FAQ 20-05: RBS Unplanned Scram May 2019
Final Approved

Plant: River Bend Station, Unit 1
Date of Event: 5/31/2019
Submittal Date: October 09, 2020
Licensee contact: Timothy Schenk Tel/email: 225-381-4177 / tschenk@entergy.com
NRC Contact: Raymond Kumana Tel/email: 817-200-1970 / rkuma94@entergy.com

Performance Indicator: IE04 - Unplanned Scrams with Complications (USwC)

IE04 Unplanned Scrams with Complications - Flowchart
Figure 2

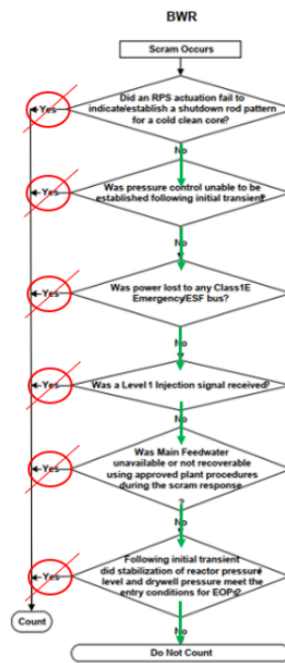
Based upon the above timeline and NEI 99-02 Rev. 7 definitions, RBS was outside the "Scram Response Time" by 30 minutes before the subsequent level three scram signal and therefore did not have an Unplanned Scram with Complications. Additionally, the below flowchart demonstrates this conclusion as seen in NEI 99-02 Rev.7, Figure 2.

The resident inspectors believe the May 31, 2019 scram is an unplanned scram with complications based on answering “Yes” to NEI 99-01 Revision 7, “IE04 Unplanned Scrams with Complications – Flowchart” questions #5 and #6.

On Question #5, “Was main feedwater unavailable or not recoverable using approved plant procedures during the scram response”, the resident believes the answer is “Yes.” The resident takes the word “recoverable” in the sentence to mean recoverable in a sustainable manner. Main feedwater was not recoverable in a sustainable manner using approved plant procedures because approved plant procedures did not instruct operators to un-isolate the heater string when bringing the feed pump back online. In using approved plant procedures, operators failed to un-isolate the heater string during their initial start of the feed pump. Consequently, when they secured the condensate pump per procedure, they caused the feed pump to trip, resulting in a low-level scram signal and an EOP re-entry.

NEI 99-02 provides clarifying guidance that “situations that require maintenance or repair activities or non-proceduralized operating alignments will not satisfy this question.” The situation in question required a “non-proceduralized” operating alignment in the sense that it required operators to take actions and observe restrictions that were not specified in any procedures. Specifically, to allow for sustained recovery of feed flow, operators needed to either un-isolate a heater string, or refrain from securing condensate pumps per the condensate system operating procedure. Neither of these actions or restrictions were specified in any of the procedures in use at the time, and therefore operators did not know that they applied. After the feed pump tripped, operators continued to attempt to restart it in the non-proceduralized lineup. Only after the additional restart attempts failed did operators recognize that the system needed to be realigned.

On Question #6, “Following initial transient, did stabilization of reactor pressure/level and drywell pressure meet the entry conditions for EOPs?”, NEI 99-02 offers the following clarifying guidance:

The guidance clearly indicates that the scope of the question includes the period after the plant has been initially stabilized and EOP's have been exited, where operators are stabilizing the remainder of the plant to allow for the use of normal operating procedures. The station was in that period when the second EOP entry occurred. Due to the abnormal feed system lineup that the station implemented during the initial response and stabilization, an abnormal condition developed in a scram response related vessel parameter—specifically, reactor vessel level—that required re-entry into EOPs.

If the USwC performance indicator only applied during the brief window between the scram and the initial stabilization that allows for EOP exit, then the above guidance--in particular, the specification of EOP re-entry as a basis for triggering the USwC PI--would not make sense. As soon as the EOP was exited, the window of applicability for the PI would close, preventing EOP re-entry from triggering the PI. The clarifying language explicitly calls out EOP re-entry as a basis for triggering the PI, so an interpretation that closes out the window of applicability as soon as the EOP is exited cannot be consistent with the intent.

Based on our review, it was determined that the licensee was still in the “Scram Response” window when the second scram occurred and did not meet the ‘and’ condition within the “Scram Response” definition that states in part, “*and concludes when operators have completed the scram response procedures*”, per NEI 99-02, Rev. 7.

The event details gathered from discussions with the inspectors revealed that the reactor feedwater system alignment was not prescribed in approved plant procedures, as they were operating the ‘C’ feedwater pump on isolated heater strings. As a result of this event, the licensee subsequently identified the reactor feedwater system alignment as an invalid alignment and updated plant procedures to address it. Even if the staff were to have considered the reactor feedwater system lineup as proceduralized, the second ‘C’ feedwater pump trip revealed that the reactor feedwater system was not in a stable configuration. Because the reactor feedwater system was in a lineup not covered at the time by approved plant procedures and that lineup was not stable in that it resulted in the ‘C’ feedwater pump trip, the staff determined that the reactor feedwater system could not be considered recovered. Therefore, the answer to question #5 would be ‘Yes’ and would make the classification of this scram event an USwC.

In this event, after the licensee experienced the first ‘1A and 1C’ feedwater pump trip on low suction and inserted a manual scram as a response, the operators restarted the ‘C’ feedwater pump, but failed to un-isolate the ‘B’ heater string, which caused the ‘C’ feedwater pump to trip on low suction pressure for a second time. This second ‘C’ feedwater pump trip caused a full RPS actuation on reactor vessel Level 3 and required a second entry to EOP-001, “RPV Control.” The criteria in this question is used to verify that there were no other conditions that developed during stabilization of the plant in the scram response related vessel parameters that required continued operation in the EOPs, re-entry into the EOPs, or transition to a follow-on EOP. Because the operators were attempting to restart the ‘C’ feedwater pump without the correct alignment, which resulted in a second automatic scram and re-entry to EOP-1, the answer to question #6 would be ‘Yes’.

In conclusion, upon reviewing the event details, prior applicable FAQs, and discussing the circumstances surrounding the May 31st, 2019 reactor scram, the staff determined that this event should be classified as an Unplanned Scram with Complications (IE03). No changes to NEI 99-02 needed as a result of this FAQ.
